Subject: Response to B&W's Modified Burner Design

The following are IPSC's comments on B&W's modified burner design proposed in the 10/15/91 meeting in Los Angeles. At this meeting B&W presented burner drawings and requested DWP approval by 10/18/91 to proceed with fabrication for the IGS Unit 1 burners.

INTERMOUNTAIN POWER PROJECT MODIFIED BACK PLATE

Figure 39 Segmented Back Plate

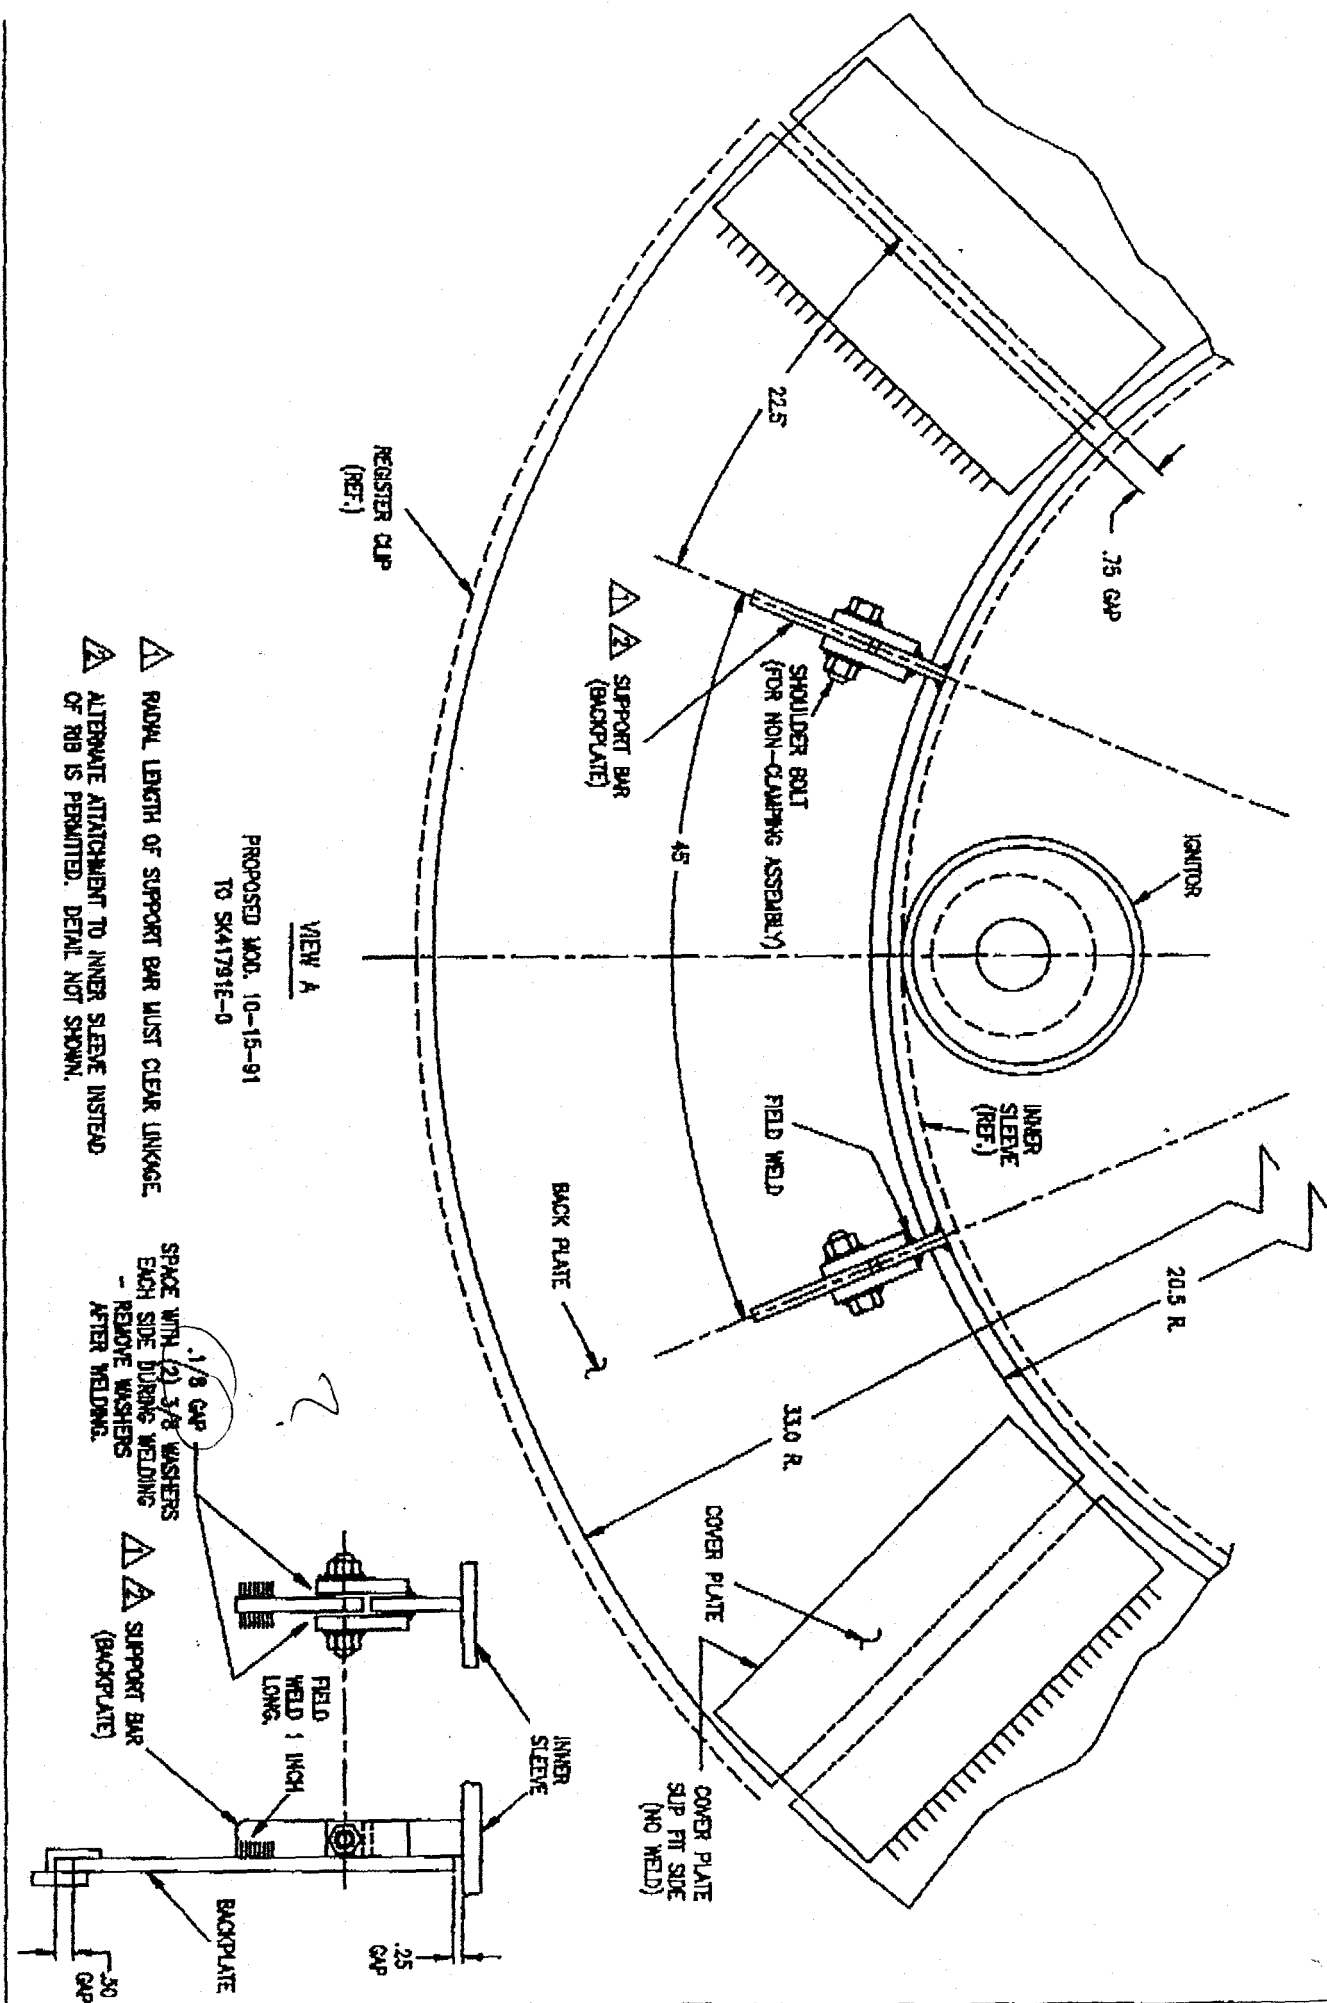
- a. Circumferential Clearance between Segments- Total circumferential clearance should equal 3 inches. With six segments as B&W has recommended, the radial clearance between segments should be 0.5 inches. If this gap is triangular shaped, minimum clearance should remain 0.5 inches.
- b. Radial Clearance between Segments- Radial clearance on each of the backplate segments should be 0.25 at the inner annulus (ID) and 0.5 on the outer annulus (OD) for thermal growth allowances.
- c. Backplate Axial Support- Axial support needs to be provided to center each of the backplate segments to allow for the radial and axial clearances previously stated. RJM has recommended a shoulder bolt attachment arrangement (drawing enclosed) which we would like to see utilized unless a better attachment can be proposed.

- d. Outer Annulus Radial Support- Additional radial supports should be provided to the outer annulus of the backplate assembly, beyond the support provided by the additional support rails proposed by B&W. We are recommending additional radial supports attached to the outer ring and anchored to the axial braces on the nozzles support sleeve (a minimum of four; one per each of the six backplate segments minus the two rail supports).
 - e. Segment Cover Plate- A slip fit cover plate is recommended to be attached to each segment joint to minimize air leakage.
2. Throat Sleeve Assembly:
- a. Throat Sleeve Radial Supports- Radial supports need to be included on the throat sleeve assembly to ensure centering of this sleeve.
3. Scanner: Recommend the second scanner issue be placed on hold until after the return of Unit 2 from its Fall Outage.
